ETC® Release Note

Eos™ Lighting Control System Software

Version 1.1.0 software

500002313

Key-Cap Update

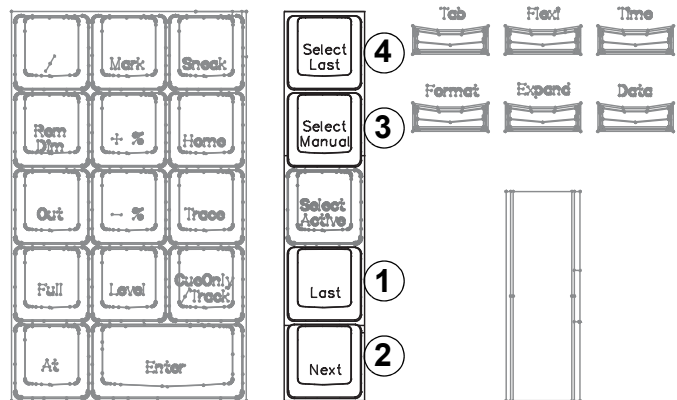
From Eos v1.0 to v1.1, four (4) keys have been re-mapped and require that you move the physical keys on the console keyboard to match the software.

- Step 1: Use the key puller provided to remove the four keys shown below in the order indicated.
- Step 2: Place the keys in their new correct positions and press them down firmly.

This is the **correct final position** for the keys. Only the four dark keys in this column need to be moved.
